ONSITE SANITATION City of Portland – Bureau of Development Services
 1900 SW 4th Avenue, Portland, Oregon 97201 – 503-823-6892 – TTY 503-823-6868 – www.portlandoregon.gov/bds
SEPTIC REVIEW CERTIFICATION (Land Use/Planning)

Address of Proposed Work: 13195 NW McNamee Rd

Description of proposed work for this Septic Planning Review 4-bedroom new single family residence with attached carport, pool, and hot tub

Permit No. 19-201244-SE

PARTIAL SITE PLAN AT BUILDING AREA SEE SP1 FOR OVERALL SITE DIMENSIONS & DISTANCES

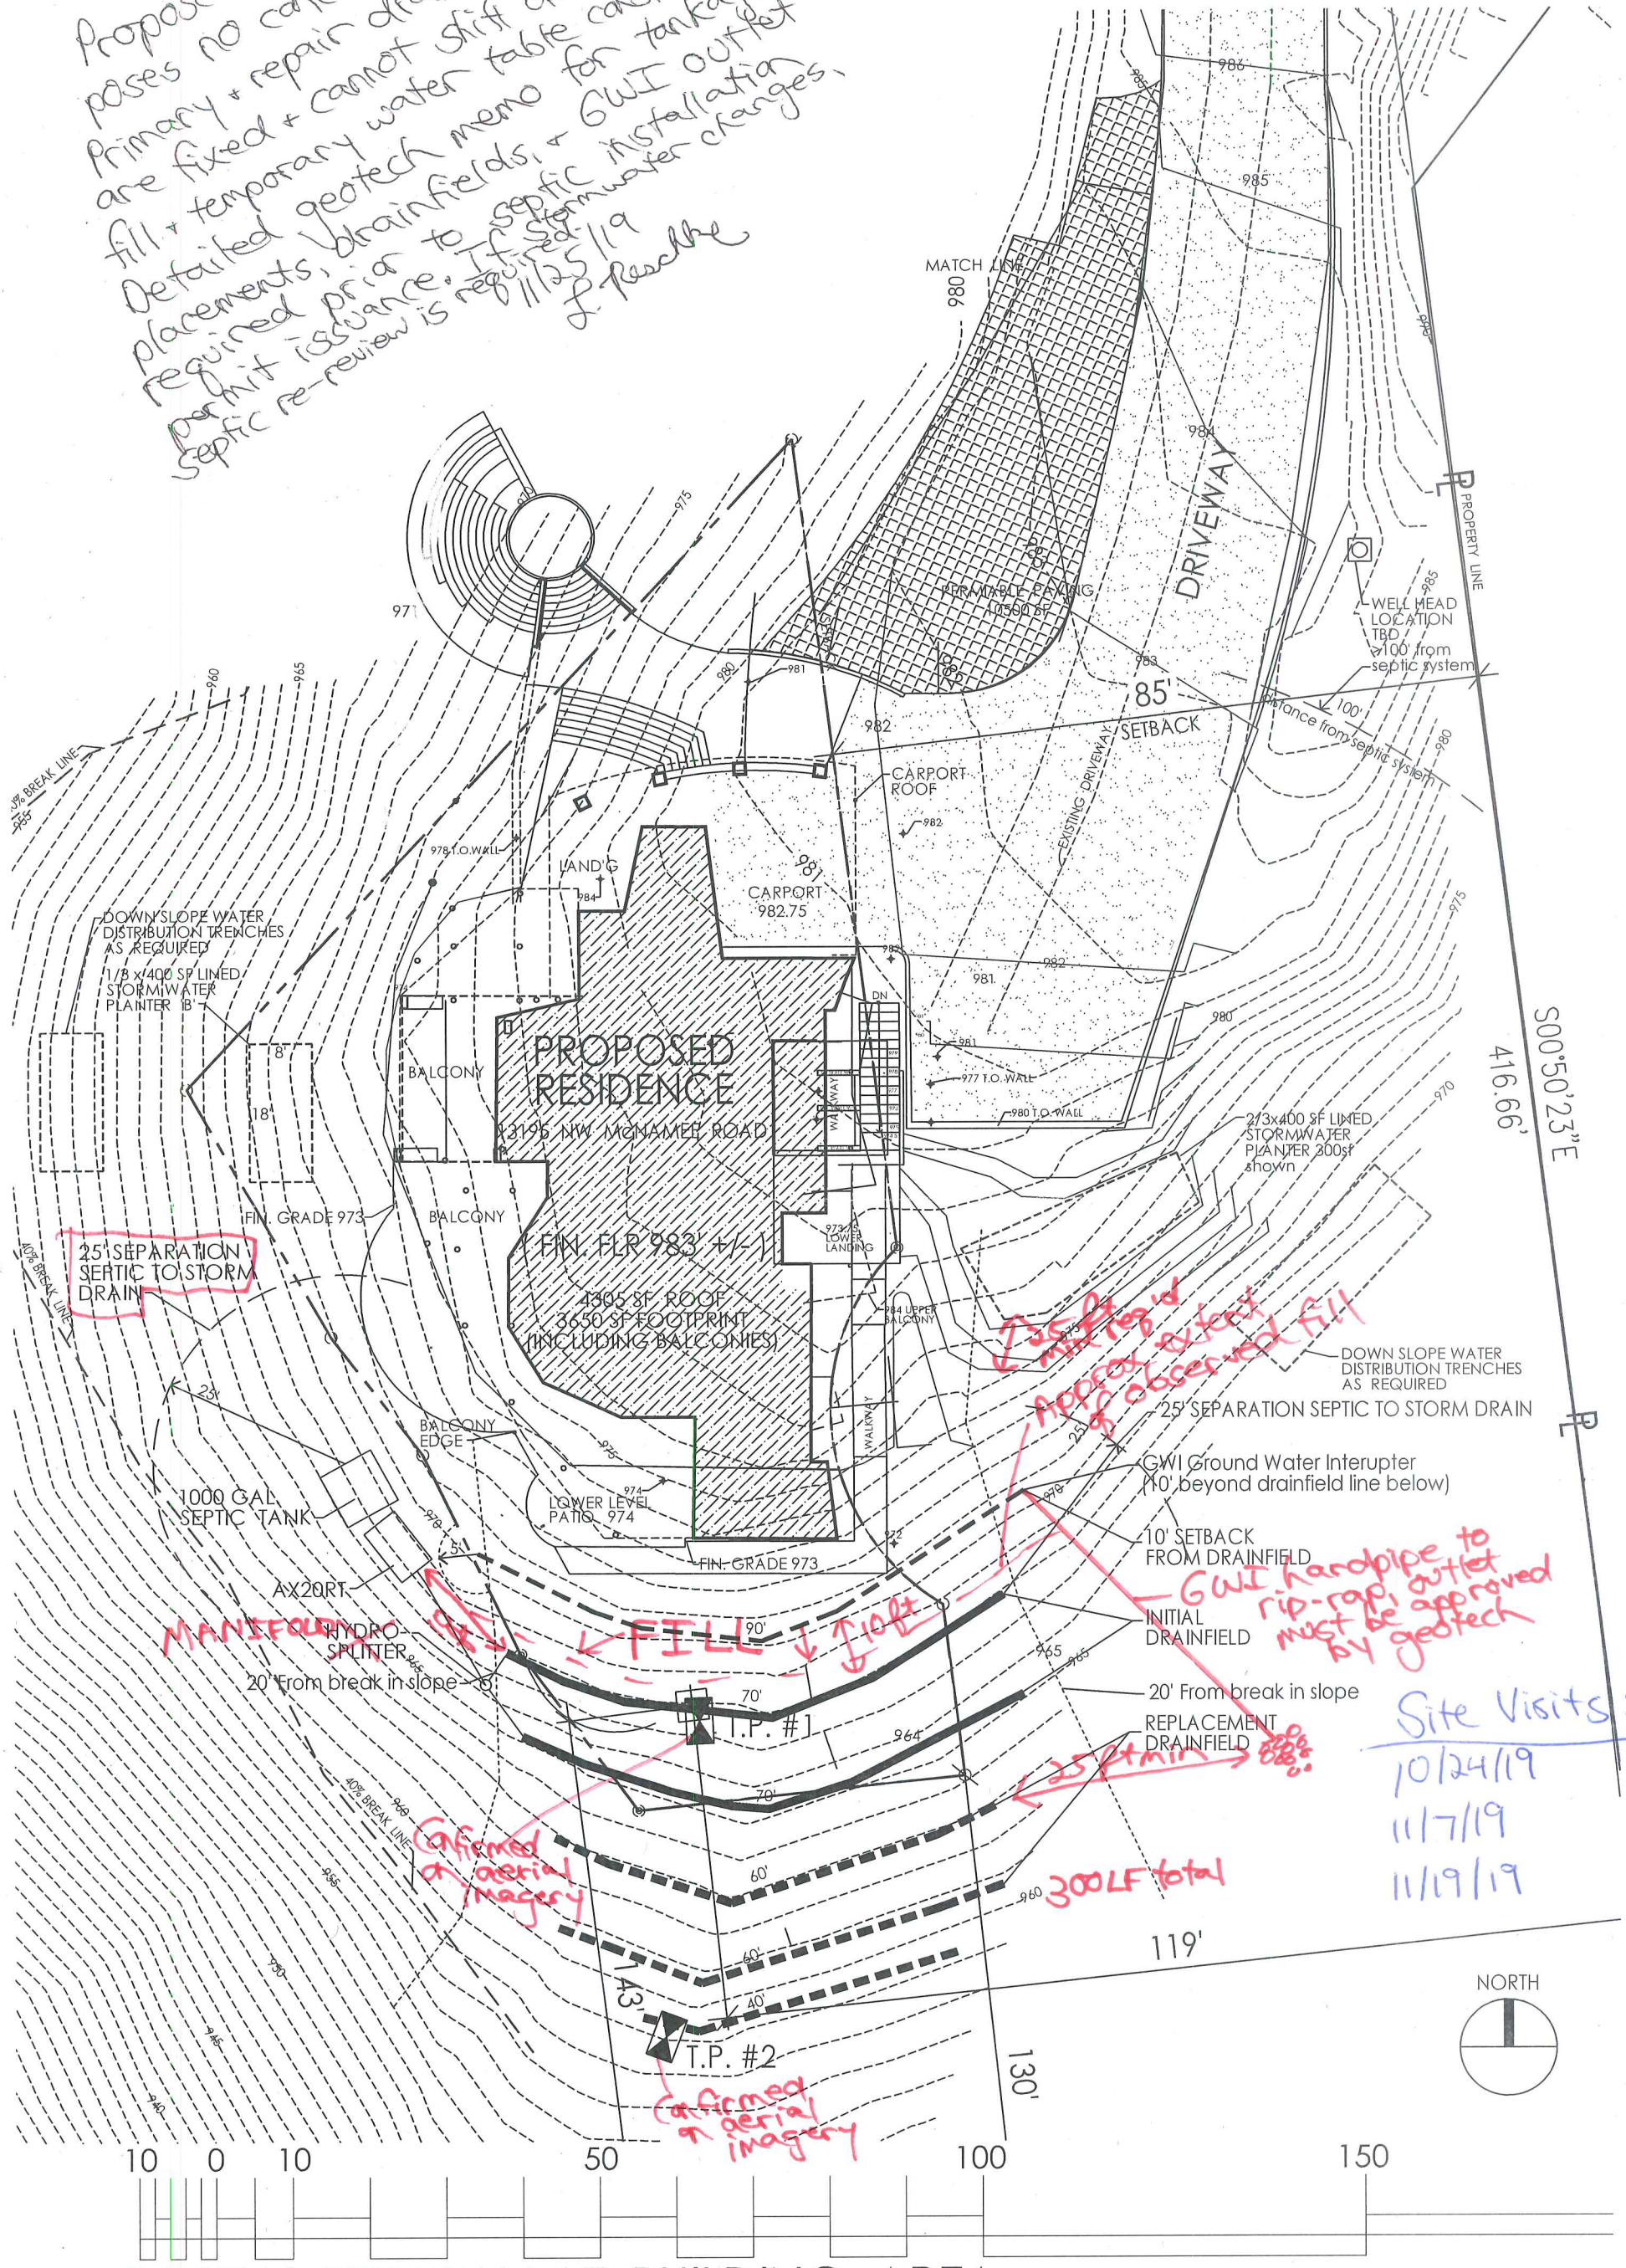
The proposed 4-bedroom single family residence poses no concern to septic. Primary and repair drainfields are fixed and cannot shift due to fill and temporary water table constraints. Detailed geotechnical memo for tankage placements, drainfields, and groundwater interceptor outlet required prior to Septic Installation Permit issuance. If stormwater changes, septic re-review is required.

Proposed 4BR SFR poses no concern to septic. Primary + repair drainfields are fixed + cannot stiff due to fill + temporary water table constraints. Detailed geotech memo for tankage placements, drainfields, + GWI outlet required prior to septic installation permit issuance. If stormwater charges, septic re-review is required. 11/25/19 J. Paschke
